Work Order ID 123081

Item Name: Floor Provisions - Energy Attenuating Seat Compatible

DART SERVICE INSTRUCTION

TO AMEND INSTALLATION INSTRUCTIONS IIN-D350-689 REV. B AND INSTRUCTIONS FOR CONTINUED AIRWORTHINESS ICA-D350-689 REV. 1

FIGURE 1: UPDATES TO CROSS SECTIONS F-F AND M-M
 With reference to Figures 5 and 7 of IIN-D350-689
 (Figures 25-5 and 25-7 of ICA-D350-689)

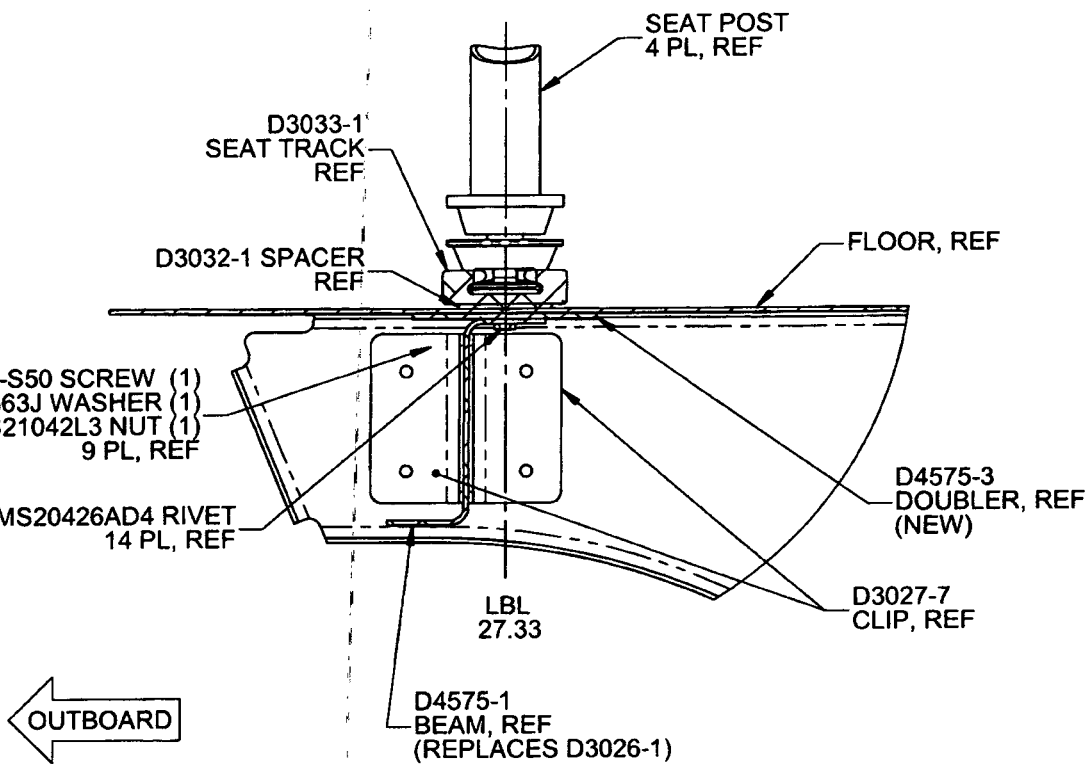
If there is an existing stringer at LBL 27.33, it will need to be removed from that location. Locate D4575-1 Beam, D4575-3 Doubler, and D3032-1 Spacer as shown in Figure 1 of this Service Instruction. Transfer drill existing holes from the aircraft floor to the D4575-1 Beam, D4575-3 Doubler, and D3032-1 Spacer. Ensure 1.0" to 1.5" rivet pitch and add additional holes if required. If there is no existing stringer, locate D4575-1 Beam, D4575-3 Doubler, and D3032-1 Spacer as shown in Figure 1 of this Service Instruction and drill Ø0.128" holes on a 1.0" to 1.5" pitch.

If there is an existing stringer at LBL 27.33, it will need to be removed from that location. Locate D4575-1 Beam and D4575-3 Doubler as shown in Figure 2 of this Service Instruction. Transfer drill existing holes from the aircraft floor to the D4575-1 Beam and D4575-3 Doubler. Ensure 1.0" to 1.5" rivet pitch and add additional holes if required. If there is no existing stringer, locate D4575-1 Beam and D4575-3 Doubler as shown in Figure 1 of this Service Instruction and drill Ø0.128" holes on a 1.0" to 1.5" pitch.

FIGURE 3: RELIEFS ON D4575-1/-3
(ONLY D4575-1/-3 SHOWN FOR CLARITY)
VIEW LOOKING INBOARD

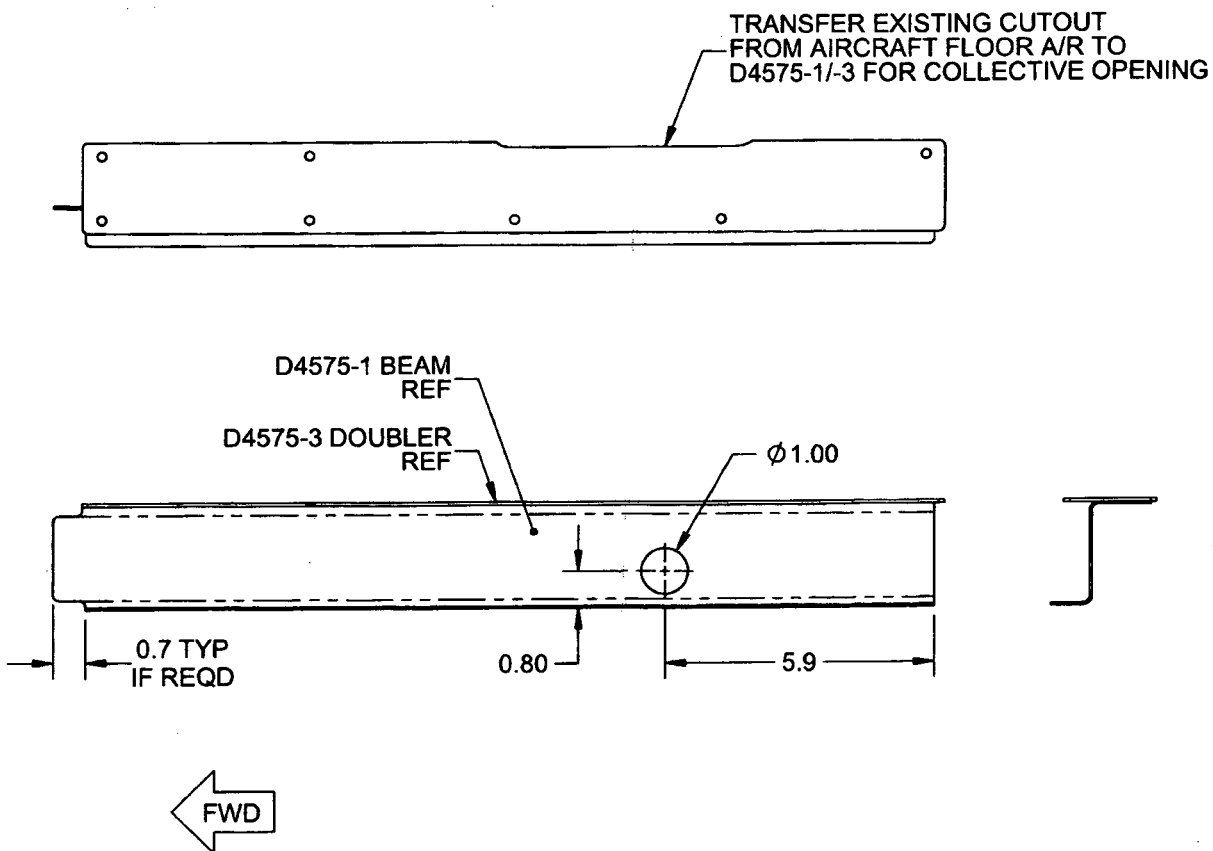
Note: Drill a Ø1.00" (Ø25.4 mm) hole in the D4575-1 Beam to clear extension tube of collective and cutout as required for clearance of collective opening and fwd bulkhead as shown in Figure 3 of this Service Instruction.

Note: Drill a Ø1.00" (Ø25.4 mm) hole in the D4575-1 Beam to clear extension tube of collective and cutout as required for clearance of collective opening and fwd bulkhead as shown in Figure 3 of this Service Instruction.
